2CAN080401

Subject: License Renewal Application Clarifications  
TAC No. MB8402  
Arkansas Nuclear One – Unit 2  
Docket No. 50-368  
License No. NPF-6

**LRA Clarifications**

### SBO Offsite Power Recovery Diagram

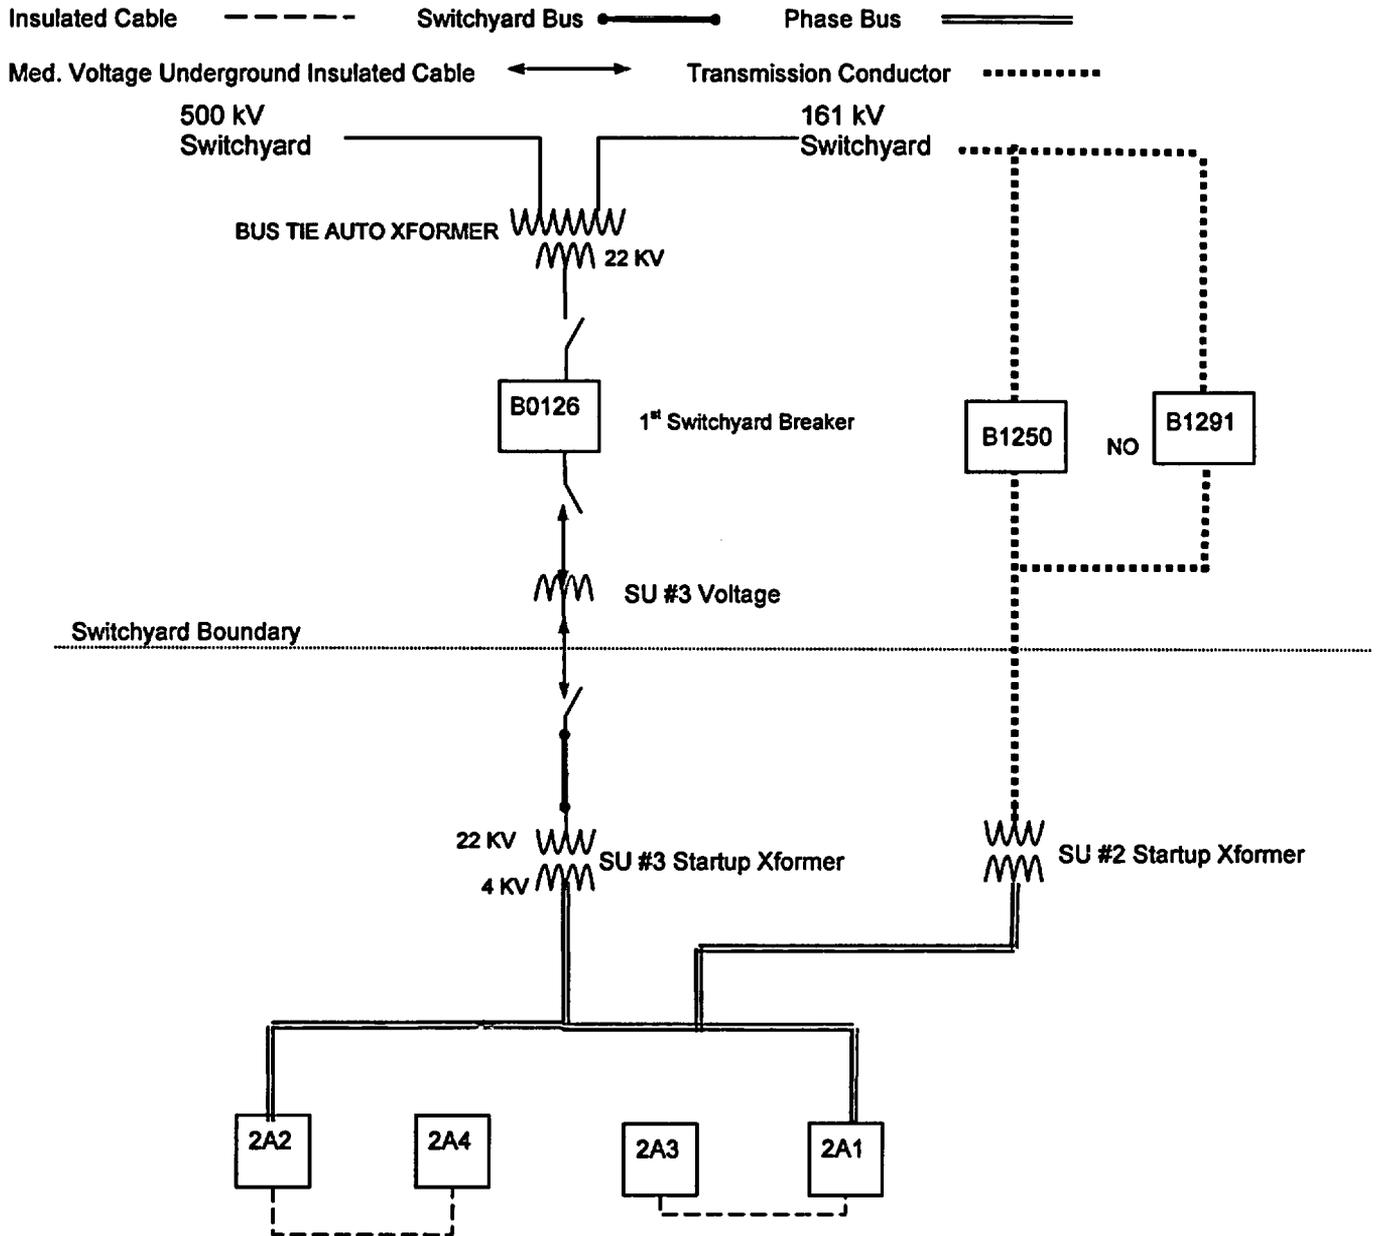
**RAI 2.5-2 Clarification:** The Staff requested Entergy to include a second offsite power source for SBO recovery as discussed in ISG-2.

**Additional Response:** Entergy included in the scope of license renewal only the ANO-2 offsite power components required for SBO recovery, which included the connections from Startup 3 to Switchyard Breaker B0126. During a meeting with the Staff on July 20, 2004, the Staff requested that Entergy include a second offsite power source in the scope of license renewal. The second offsite power source is an ANO-1 component credited for General Design Criterion (GDC) 17. Entergy agreed to consider the second source, Startup Transformer #2, in the scope of license renewal and subject to aging management review.

With inclusion of the alternate path for SBO recovery, a description of Startup Transformer #2 and the connection to the 161kV switchyard is provided.

SAR Section 8.2.1.2.G describes the overhead 161kV transmission conductors from 161kV switchyard breakers B1291 and B1250 to Startup Transformer #2. The high-voltage insulators associated with the transmission conductors are similar to the high-voltage insulators for the switchyard bus, which are already addressed in LRA Section 3.6.

The added 161kV switchyard circuit breakers B1291 and B1250, the overhead transmission conductors, and Startup Transformer #2 are shown on the sketch below.
